TENDER NO: 2022-19

One Mile Lift Station and Egbert Street Forcemain

ADDENDUM

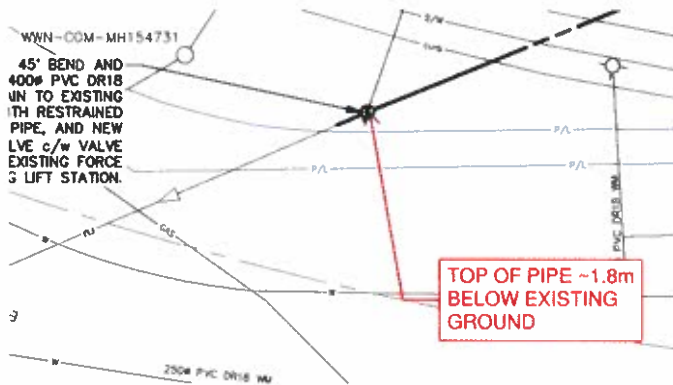
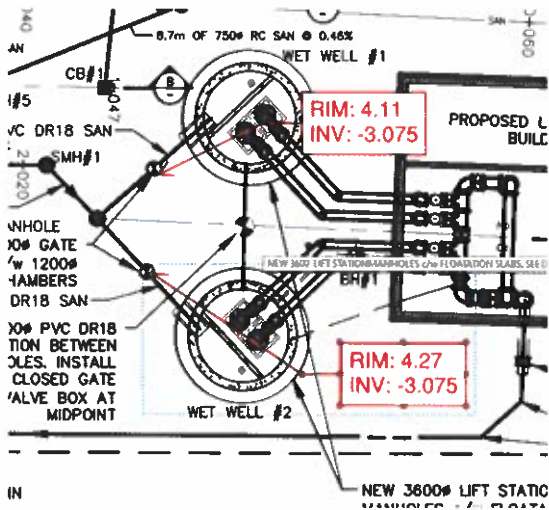
Q1. Please verify pipe material between Splitter Manhole and Wet-Well #1 and Wet-Well #2 on one page it notes it as RCP on another it is PVC”

A1. The pipe material between Splitter Manhole and Wet-Well #1 and Wet-Well #2 shall be 600mm diameter PVC DR18 pipe.

Sheet C06 (6 of 32):

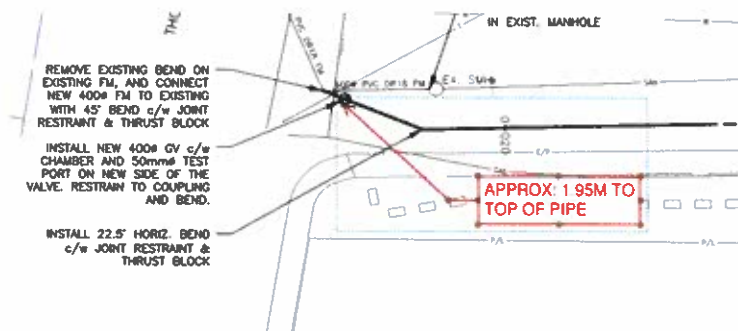
Q2. Please provide top elevations and invert or floor elevations for the valve chambers.

A2. See sketches below:

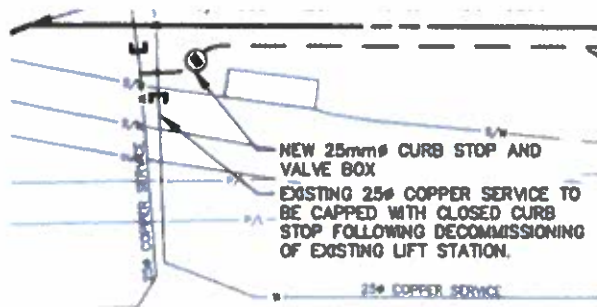
Q6. Please verify floor elevations and inlet elevations for wet-wells; sheet 18 of 32 – elevation of inlet pipe = -3.09m / floor elevation = -4.33m, Sheet 28 of 32 – elevation of inlet pipe = -2.45m / floor elevation = -3.82m

A6. Use the elevations on Sheet 18 (M01).

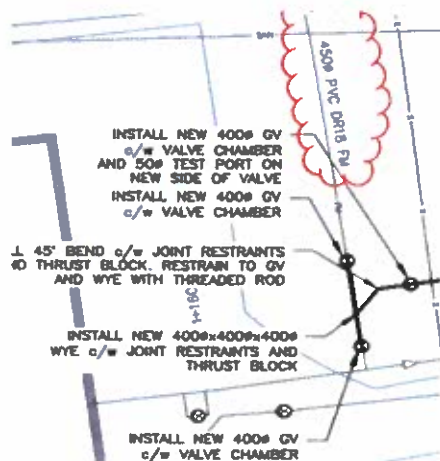
Q16. Is the 450mm PVC DR18 FM correct? Or is a reducer required at each end of this connection?

A16. The force main is a 400mm dia. PVC DR18.

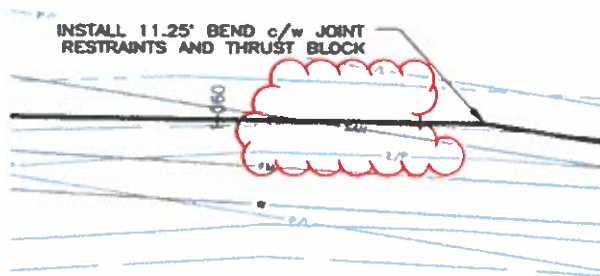
Q17. What is the depth of the existing 600mm concrete sanitary pipe at this crossing?

A17. The invert of the 600mm concrete sanitary pipe at the crossing is approximately +0.05m.
